UNITED STATES PATENT AND TRADEMARK OFFICE

APPLICATION NO.	FILING DATE	FIRST NAMED INVENTOR	ATTORNEY DOCKET NO.	CONFIRMATION NO.
10/061,699	02/01/2002	Scott C. Young	LEG03 P-317	1548

Office Action Summary

Attachment A

F21B34

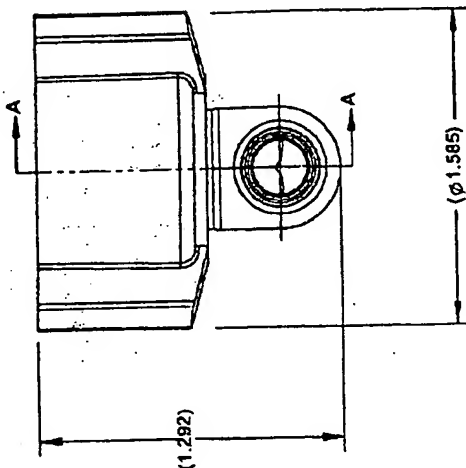
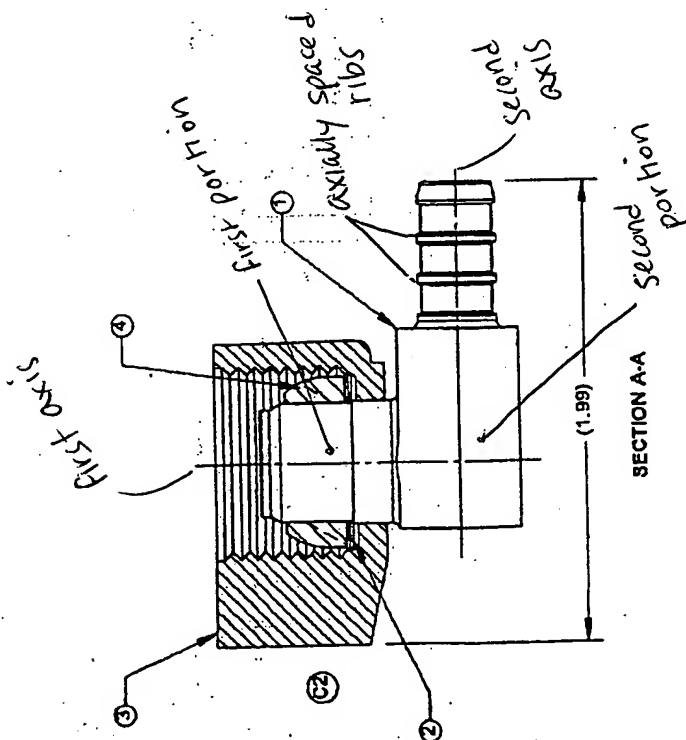
With respect to claim 1, the document depicting Marshall Brass' Part F21B34 (hereinafter "The F21B34 document") shows a swivel drop ear elbow fitting comprising: a threaded nut (3) including a plurality of integrated ears (see Attachment A) located along an external periphery of the threaded nut; a retaining ring (2); and a hollow elbow adapter (1) including a first portion centrally positioned with respect to a first axis (see Attachment A) and a second portion centrally positioned with respect to a second axis (see Attachment A), wherein the second axis is not colinear with the first axis, and wherein an outer surface of the first portion is shaped to receive the retaining ring (see "Section A-A") which retains the threaded nut on the first portion of the hollow elbow adapter while allowing the hollow elbow adapter to rotate (swivel) with respect to the threaded nut. The F21B34 document does not disclose that the ears include an aperture for receiving a fastener for securing the threaded nut to a stationary support. The F26B44 document teaches a drop ear elbow fitting having a plurality of attachment ears each with an aperture therein for securing the threaded nut of the fitting to a support (stationary or otherwise). In view of the teaching of document F26B44, it would have been obvious to one having ordinary skill in the art at the time the invention was

With respect to claim 6, wherein an outer surface of the second portion of the hollow elbow adapter includes a plurality of axially spaced ribs (see Attachment A).

With respect to claim 10, the document depicting Marshall Brass' Part F21B34 (hereinafter "The F21B34 document") shows a swivel drop ear elbow fitting comprising: a threaded nut (3) including a plurality of integrated ears (see Attachment A) located

along an external periphery of the threaded nut; a retaining ring (2); and a hollow elbow adapter (1) including a first portion centrally positioned with respect to a first axis (see Attachment A) and a second portion centrally positioned with respect to a second axis (see Attachment A), wherein the second axis is not colinear with the first axis, and wherein an outer surface of the first portion is shaped to receive the retaining ring (see "Section A-A") which retains the threaded nut on the first portion of the hollow elbow adapter while allowing the hollow elbow adapter to rotate (swivel) with respect to the threaded nut; and a seal (4) with an inner diameter sized to receive the first portion of the hollow elbow adapter and an outer diameter sized to substantially eliminate fluid leakage between the end fitting and an external fitting that is threadingly received by the threaded nut* (see above Note). The F21B34 document does not disclose that the ears include an aperture for receiving a fastener for securing the threaded nut to a stationary support. The F26B44 document teaches a drop ear elbow fitting having a plurality of attachment ears each with an aperture therein for securing the threaded nut of the fitting to a support (stationary or otherwise). In view of the teaching of document F26B44, it would have been obvious to one having ordinary skill in the art at the time the invention was made to modify the ears of the F21B34 document with apertured attachment ears in order to permit the threaded nut of F21B34 to be attached to a support.

With respect to claim 15, wherein an outer surface of the second portion of the hollow elbow adapter includes a plurality of axially spaced ribs (see Attachment A).

With respect to claim 17, the document depicting Marshall Brass' Part F21B34 (hereinafter "The F21B34 document") shows a swivel drop ear elbow fitting comprising: a threaded nut (3) including a plurality of integrated ears (see Attachment A) located along an external periphery of the threaded nut; a retaining ring (2); and a hollow elbow adapter (1) including a first portion centrally positioned with respect to a first axis (see Attachment A) and a second portion centrally positioned with respect to a second axis (see Attachment A), and wherein an outer surface of the first portion is shaped to receive the retaining ring (see "Section A-A") which retains the threaded nut on the first portion of the hollow elbow adapter while allowing the hollow elbow adapter to rotate (swivel) with respect to the threaded nut; and a cone-shaped seat (4) made of elastomeric material (santoprene) with an inner diameter sized to receive the first portion of the hollow elbow adapter and an outer diameter sized to substantially eliminate fluid leakage between the end fitting and an external fitting that is threadingly received by the threaded nut* (see above Note). The F21B34 document does not disclose that the ears include an aperture for receiving a fastener for securing the

With respect to claim 20, wherein an outer surface of the second portion of the hollow elbow adapter includes a plurality of axially spaced ribs (see Attachment A).
